Company Name		
Schematic Name		
Designer's name	Rev 1.0 3/16/2016	Page # or name

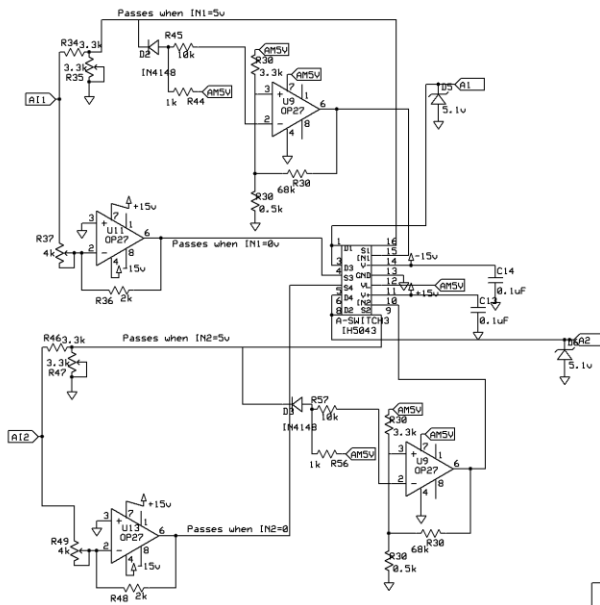
Wired correctly on the PCB 4/20

<-rename components to avoid netlist problems (linking with pcb)

<-rename components to avoid netlist problems (linking with pcb)

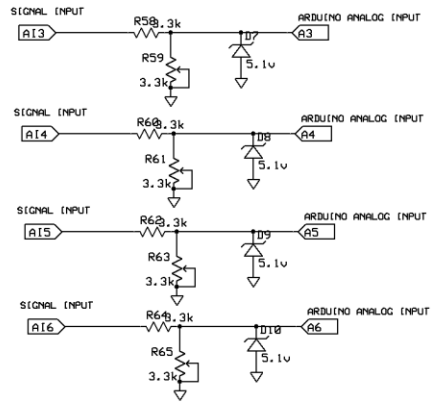
NO OP AMP NEEDED
BC NO LOADING EFFECT BY A-INPUT OF MEGA

Wired correctly on the PCB 4/28
